# ENGINEER'S INSPECTION REPORT

OFFICE OF THE STATE ENGINEER - DIVISION OF WATER RESOURCES - DAM SAFETY BRANCH

DAM NAME: BATTLE MOUNTAIN SAN LUIS TAILINGS T: 0 R: 0 S: COUNTY: COSTILLA DATE OF INSPECTION: 5/13/2013  
 DAM ID: 240109 YR Compl: 1991 DAM HEIGHT(FT): 140.0 SPILLWAY WIDTH(FT): 4.0 PREVIOUS INSPECTION:  
 CLASS: N hazard DAM LENGTH(FT): 1640.0 SPILLWAY CAPACITY(CFS): 170.0 NORMAL STORAGE (AF): 750.0  
 DIV: 3 WD: 24 CRESTWIDTH(FT): 30.0 FREEBOARD (FT): 10.0 SURFACE AREA(AC): 150.0  
 EAP: Not Required CRESTELEV(FT): 8620.0 DRAINAGE AREA (AC.): 896.0 OUTLET INSPECTED:

## Battle Mountain San Luis Project Tailings Dam: 5/13/13 Dam Safety Inspection Report

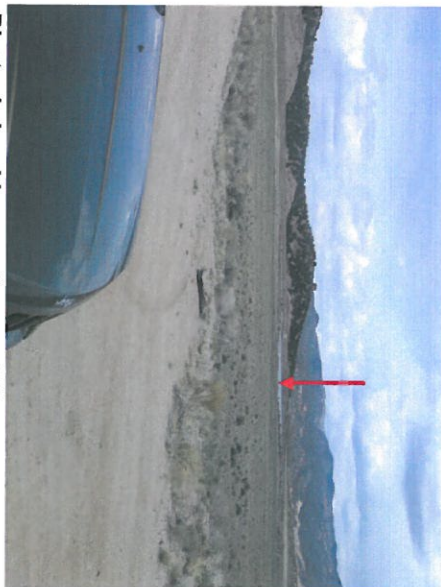
Photo 1- Looking upstream at the tailings containment area from the left abutment of the main dam. During normal operations there is only a small pool of water.
